CERTIFICATE OF APPROPRIATENESS

Property: 638 Heights Boulevard, Lot 22, Block 277, Houston Heights Subdivision. The property includes a historic 1,108 square foot, one-story wood frame single-family residence situated on a 7,500 square foot (50' x 150') interior lot.

Proposal: Alteration – Construct a 3,380 square foot two-story cementitious clad addition and attached garage at the rear of a 1,108 square foot contributing brick one-story house. An original rear bump-out and existing small rear addition will be removed and the proposed addition will start at the primary rear wall.

Recommendation: Denial - does not satisfy criteria

WEST ELEVATION – FRONT FACING HEIGHTS BOULEVARD

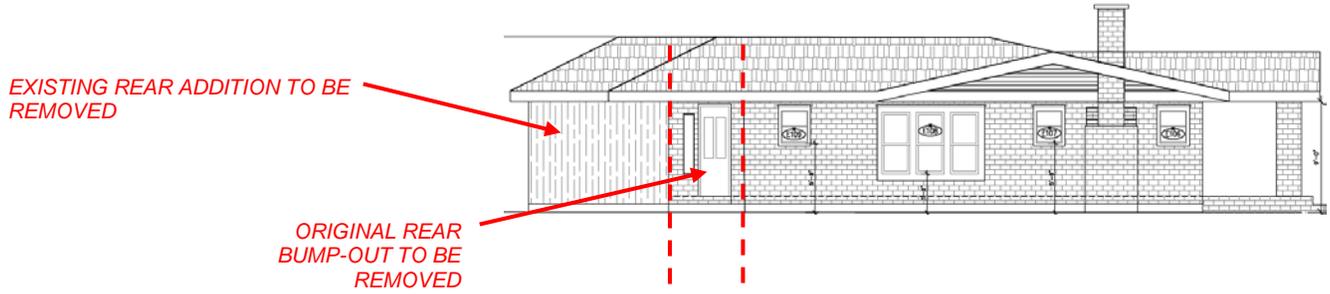
- (1) The proposed activity must retain and preserve the historical character of the property;
The historic single story character of the residence is overwhelmed by the scale and visual impact of the addition. The addition is significantly wider and taller than the historic residence and compromises the historic character of the property.

- (9) The proposed design for any exterior alterations or addition must not destroy significant historical, architectural or cultural material and must be compatible with the size, scale, material and character of the property and the area in which it is located;
The addition is significantly taller, wider and deeper than the historic residence and is not compatible with the size, scale and character of the single story residence and area.

NORTH SIDE ELEVATION

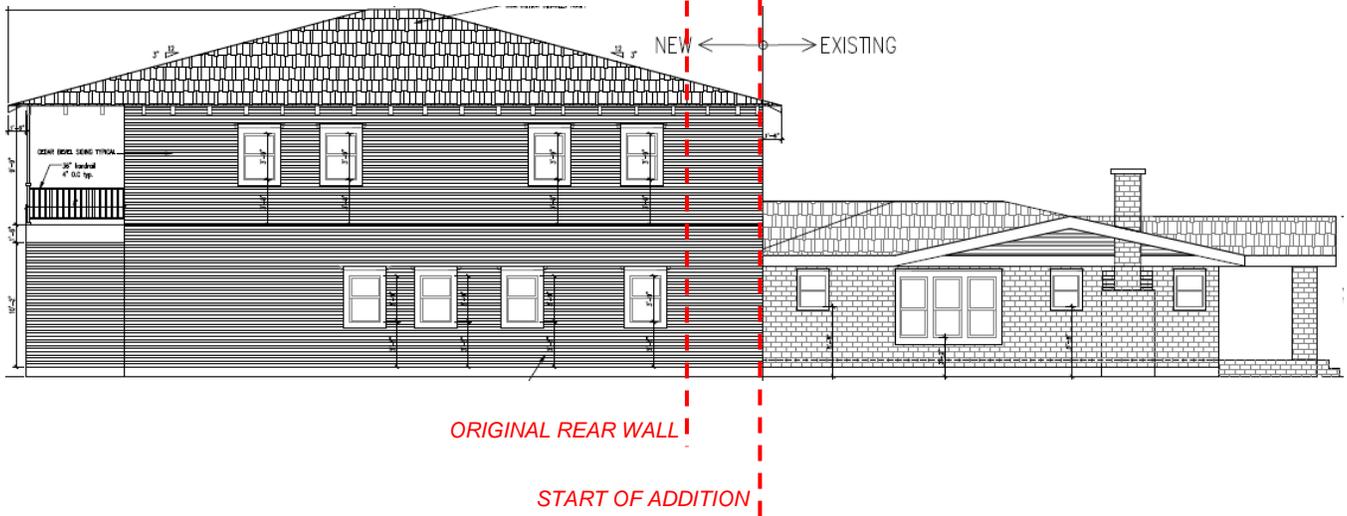
- (4) The proposed activity must preserve the distinguishing qualities or character of the building, structure, object or site and its environment;
The historic single story character of the residence is overwhelmed by the scale and visual impact of the addition. The addition is significantly wider and taller than the historic residence and compromises the historic character of the building and its environment. A reduction in its scale would increase its compatibility and preserve the distinguishing qualities of the residence and district.
